## PCI-SIG ENGINEERING CHANGE NOTICE

<b>TITLE:</b>	Error Reporting
<b>DATE:</b>	January 27, 2005
<b>AFFECTED DOCUMENT:</b>	PCI Express Base Specification 1.0a
<b>SPONSOR:</b>	Joe Cowan; Hewlett-Packard Company

Figure 6-3: Flowchart Showing Sequence of Device Error Signaling and Logging Operations

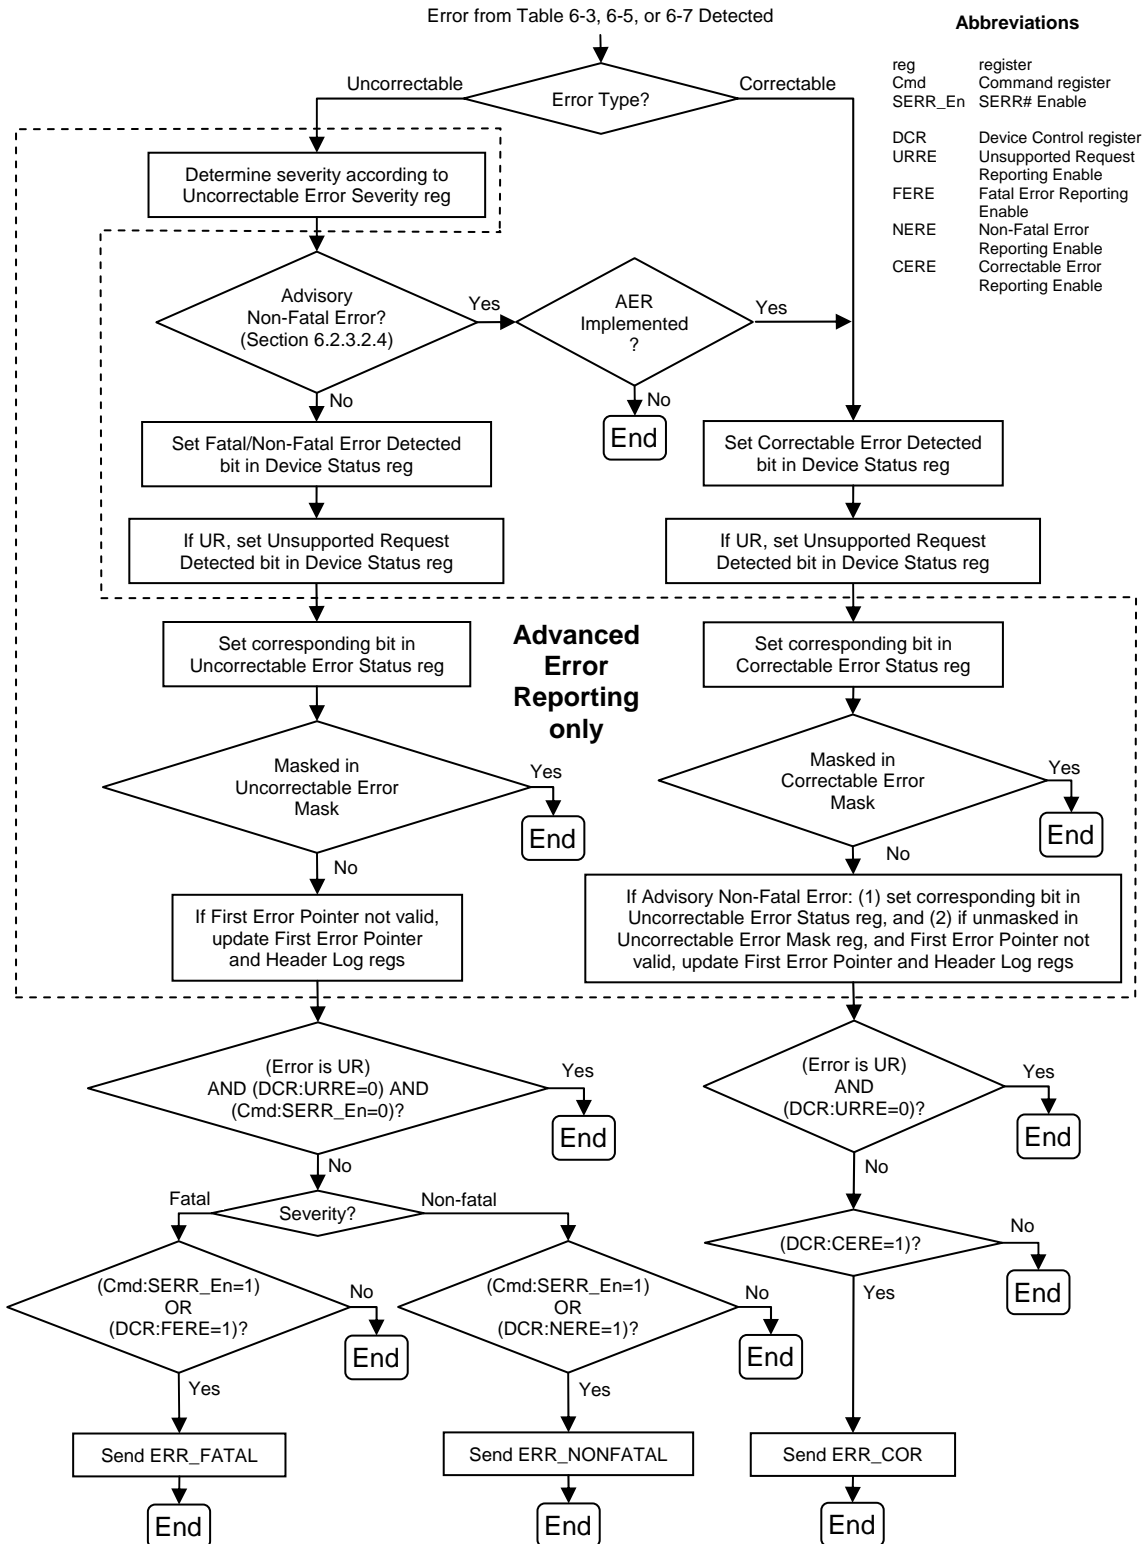
Replace Figure 6-3, page 298 with the following:

For Advisory Non-Fatal Error cases, since an uncorrectable error is signaled using the correctable Error Message, control/status/mask bits involving both uncorrectable and correctable errors apply. Figure 6-3 shows a flowchart of the sequence. Following are some of the unique aspects for logging Advisory Non-Fatal Errors.

Figure 6-xx: Pseudo Logic Diagram for Error Message Controls

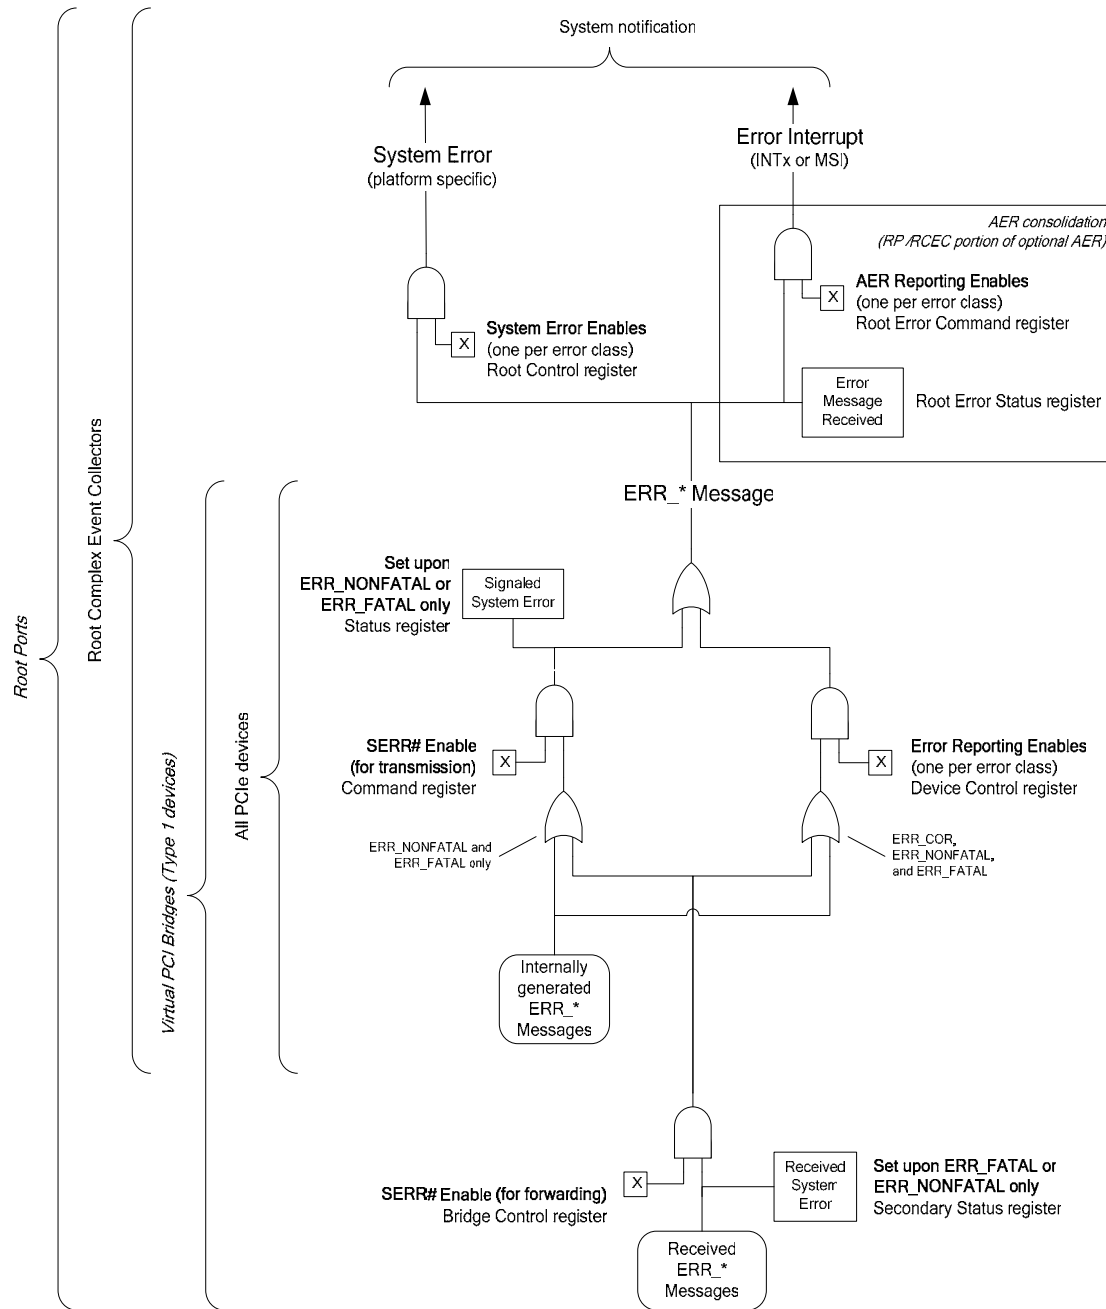
Insert new section prior to Section 6.2.6, page 299:

Error Messages have a complex set of associated control and status bits. Figure 6-xx provides a conceptual summary in the form of a pseudo logic diagram for how error Messages are generated, logged, forwarded, and ultimately notified to the system. Not all logged status bits are shown. The logic gates shown in this diagram are intended for conveying general concepts, and not for direct implementation.

Figure 7-24: Device Capabilities Register

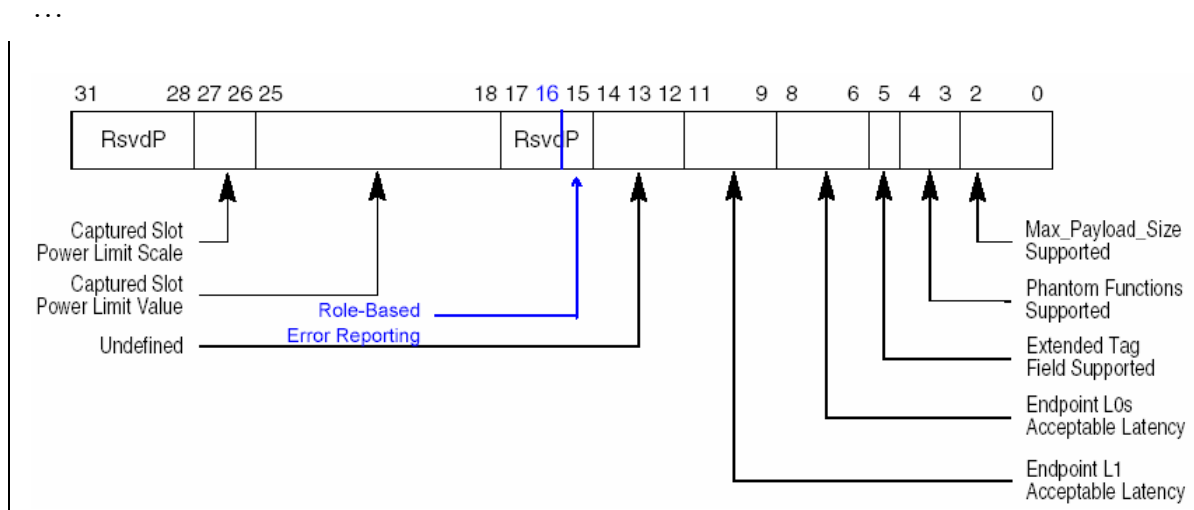
Change Section 7.8.3, page 381 as follows:

Bit Location	Register Description	Attributes
...	...	...
15	<a href="#">Role-Based Error Reporting</a> – this bit, when set, indicates that the device implements the functionality originally defined in the <a href="#">Error Reporting ECN for PCIe Base Specification 1.0a</a> , and later incorporated into <a href="#">PCIe Base Specification 1.1</a> . This bit must be set by all devices conforming to the ECN, <a href="#">PCIe Base 1.1</a> , or subsequent <a href="#">PCIe Base</a> revisions.	RO

Figure 7-61: Correctable Error Status Register

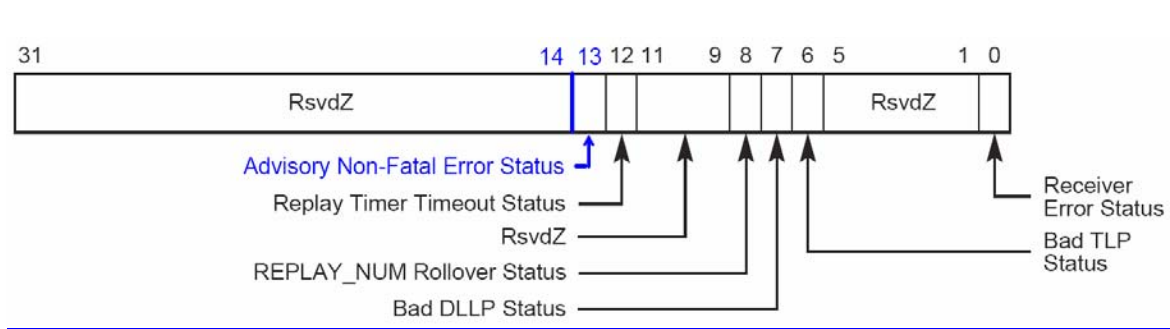
Change Section 7.10.5, page 426 as follows:

Bit Location	Register Description	Attributes	Default Value
...	...	...	...
<a href="#">13</a>	<a href="#">Advisory Non-Fatal Error Status</a>	<a href="#">RW1CS</a>	<a href="#">0</a>

**Figure 7-63: Correctable Error Mask Register**

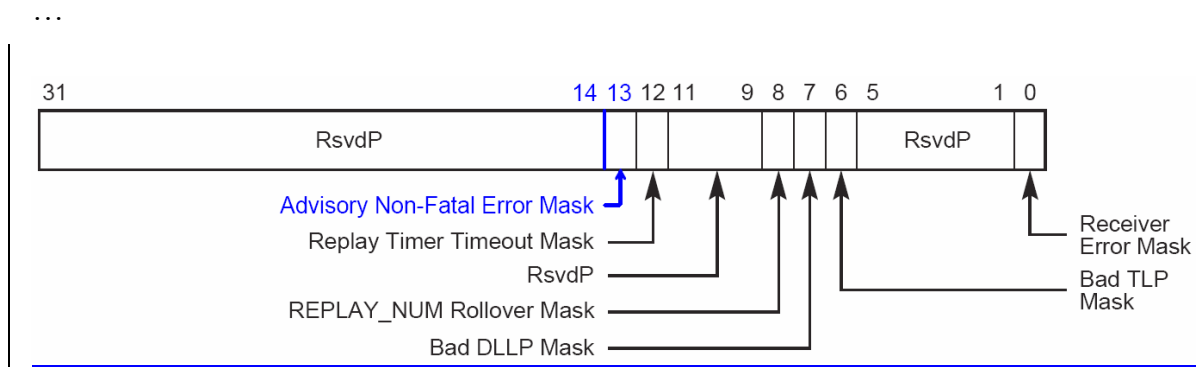
Change Section 7.10.6, page 427 as follows:

Bit Location	Register Description	Attributes	Default Value
...	...	...	...
<a href="#">13</a>	<a href="#">Advisory Non-Fatal Error Mask – this bit is set by default to enable compatibility with software that does not comprehend Role-Based Error Reporting.</a>	<a href="#">RWS</a>	<a href="#">1</a>
